**Re: Part VIII Planning Report for the construction of 16 residential units at Towerfield, Croom,
Co. Limerick**

**PLANNING REPORT IN ACCORDANCE WITH
SECTION 179 3(a) OF THE PLANNING & DEVELOPMENT
ACT 2000 (as amended)**

Planning Reference No. 19/8005

DRAWING TITLE:
PROPOSED SITE LAYOUT -
ROOF PLAN

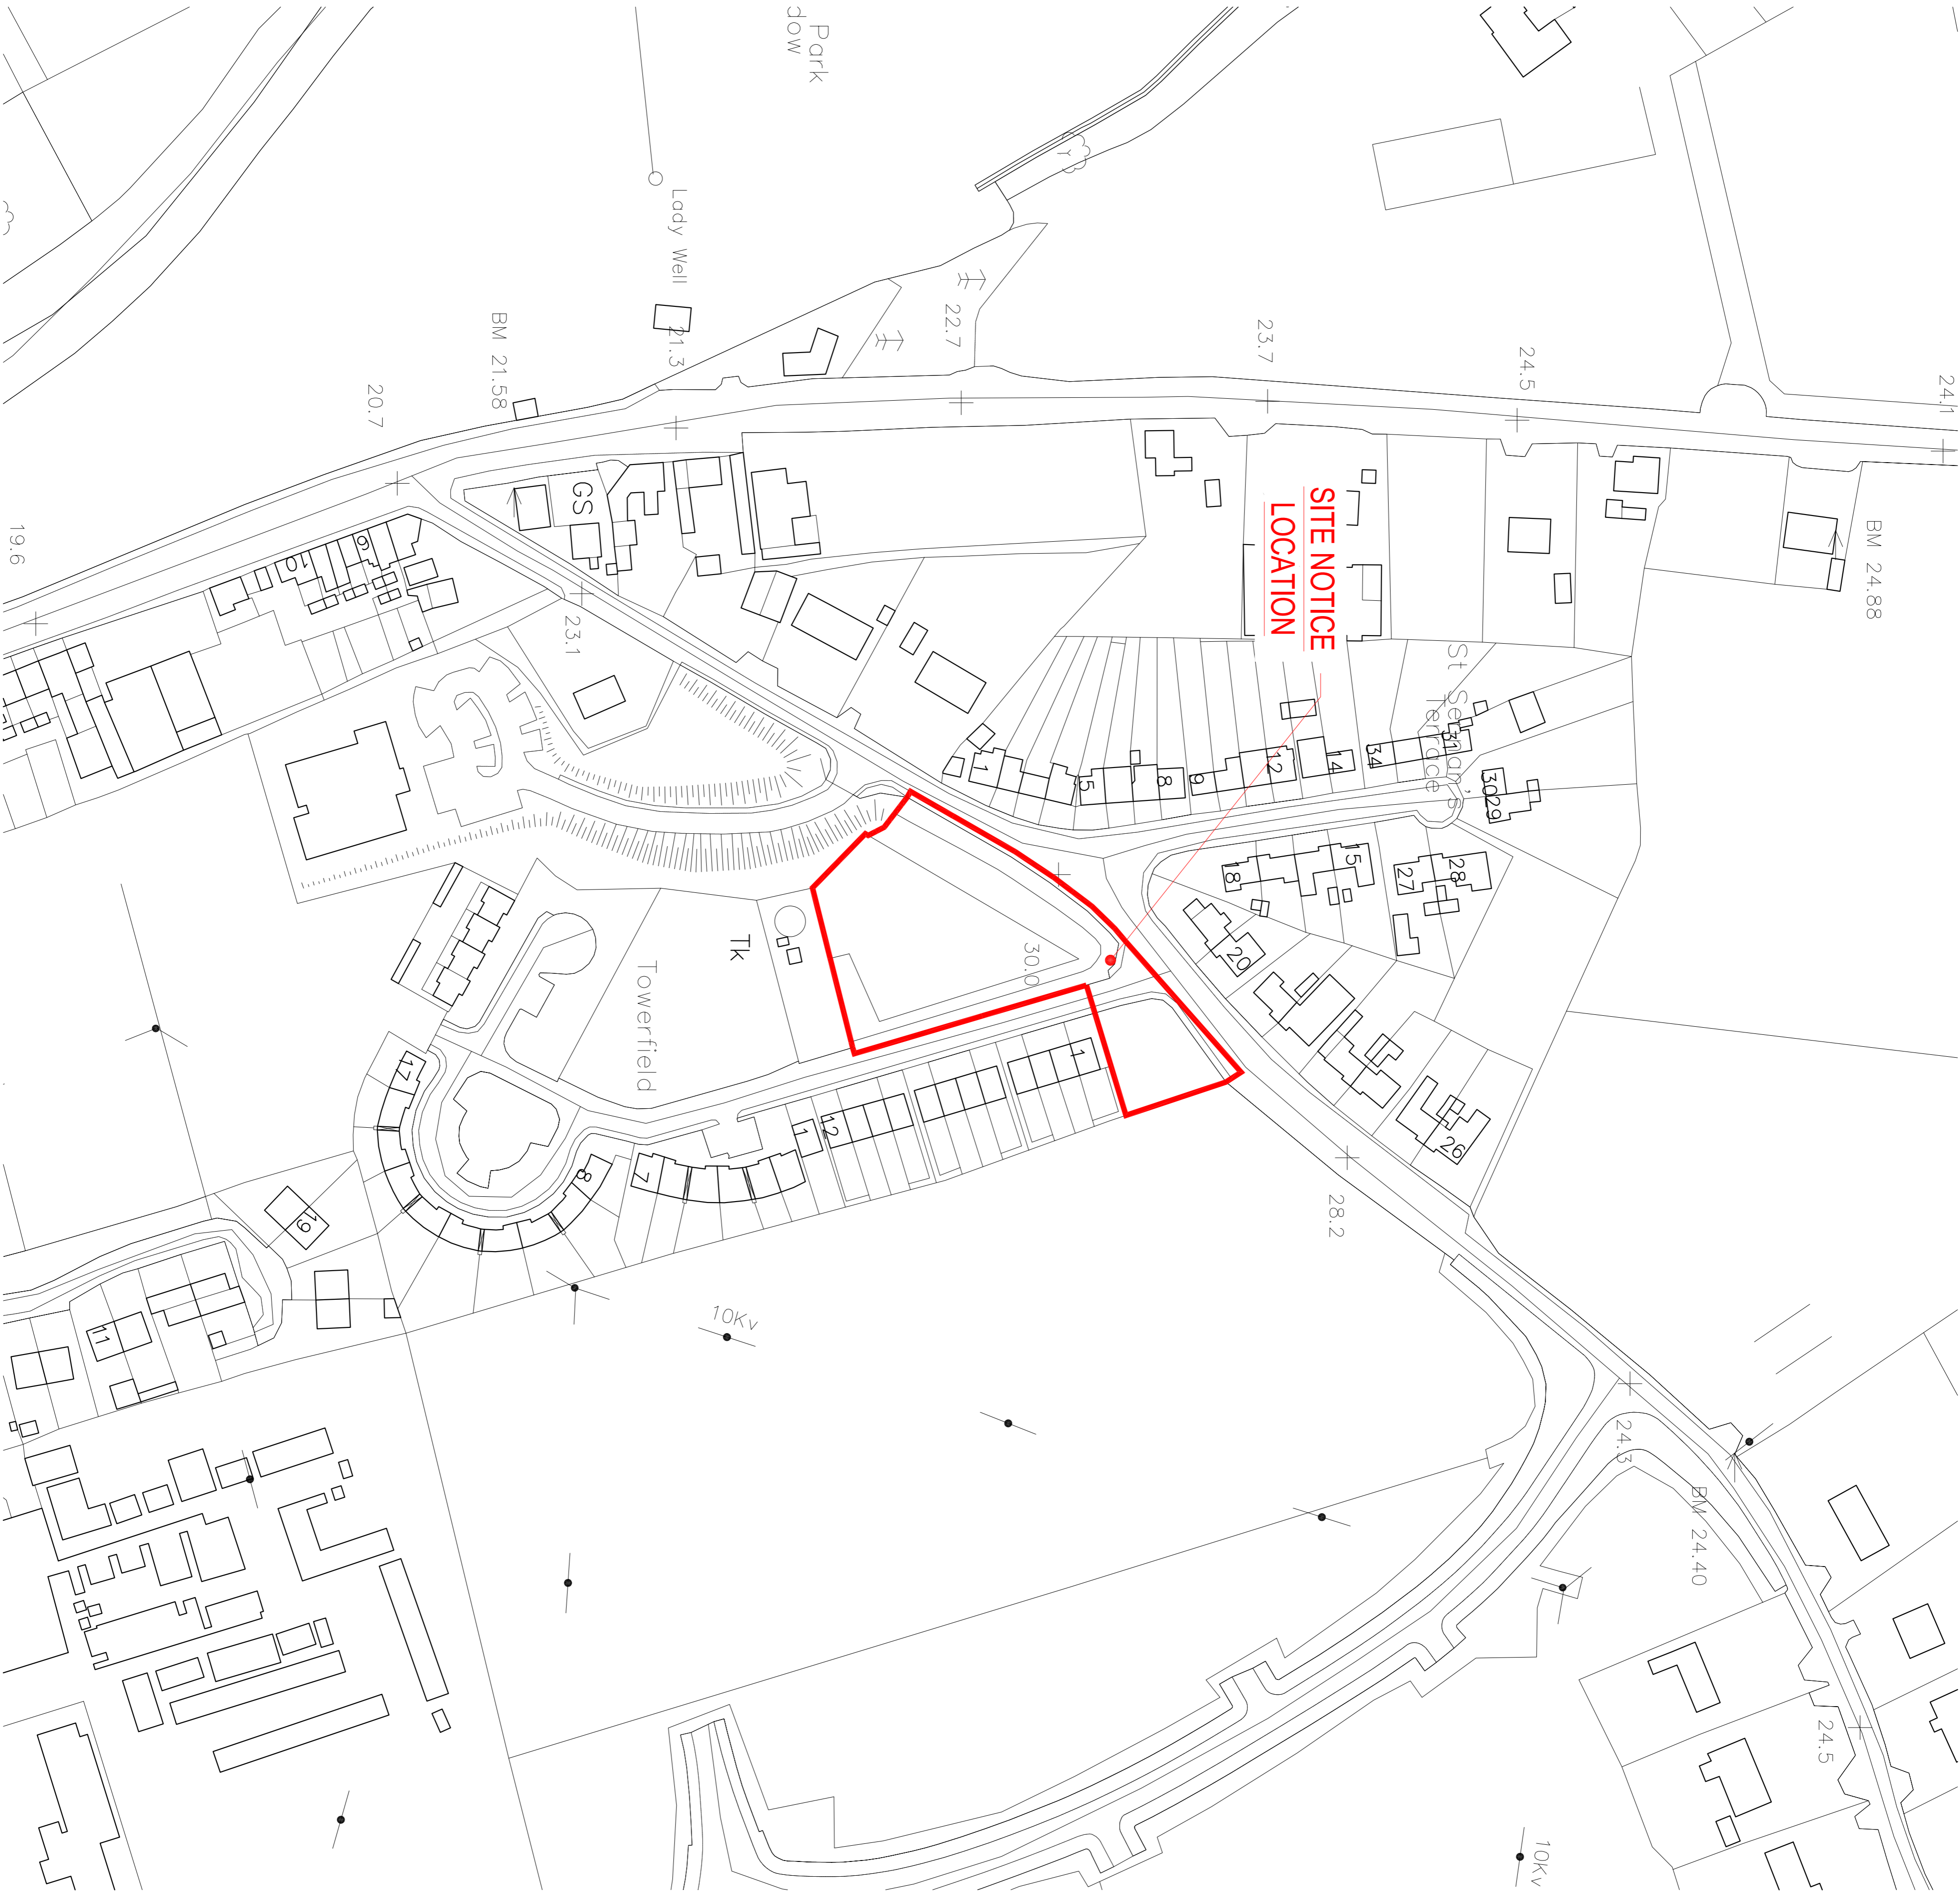
1. The applicant is required to reduce the level of the site from 34m to 30.5m approx. Details of the removal of material be moved to a licensed waste facility to be submitted.
2. A Traffic Management Plan should be submitted outlining the planned traffic movements from the site.
3. Details of the proposed retaining wall between the Water Tower and unit numbers 7 to 10 inclusive and 13 to be submitted. This wall will be retaining 2.5m of earth.
4. The drawings attached show the ground level in the gardens at the rear of house numbers 7 to 11 being 31.5m while the Water Tower Ridge is 49.88m. During the mass excavation and removal of soil offsite, there is a likelihood that pipelines from the water tower will be found. Are pipelines from the water tower being relocated away from this site and has this been agreed with Irish Water.

1. A revised Site Layout Plan should be submitted to Limerick City and County Council for approval indicating the recommendations of the Road Safety Audit.
2. The Auto Tracking should be used to access the ability to turn refuse trucks within the turning circle provided.
3. The Applicant has failed to submit sightlines for all the junctions. The Applicant shall submit a revised Sightline Layout in line with DMURS.
4. Soft landscaping located close to the junction should not interfere with the sightlines.
5. At the junction from the estate to the public road LP1408, the sightlines will be compromised by the location of 3 no. car park spaces along the LP1408 in front of house number 16.

DATE	REV.	BY	CHECKED	DESCRIPTION
10.10.2019	A	BR	SH	1. Revised roof profile to units 14 & 15. 2. Roads added revisions including reconfigured parking 3. Emergency boundary wall realignment revisions. Further reconfiguration of same, some front gardens have been extended to ensure remaining boundary areas aren't 4. Relating wall to southern boundary moved 1m into LCCD silo to ensure the Fish Water Tower site isn't disturbed during excavation and subsequent construction works.

Revision 'A' Note 4:
See '16009-112' for further detail
regarding retaining wall proposals at
the southern boundary with the Fish
Water Tower site.

Revision 'A' Note 3:
See drawing '16009-108-A' for front
garden boundary wall revisions

Revision 'A' Note 2:
See drawing '16009-108-A' for roads
and parking related revisions.

Revision 'A' Note 1:
Revised roof profile to Units 14 & 15 to
reduce the scale and impact of the
gable on the adjacent existing
property.
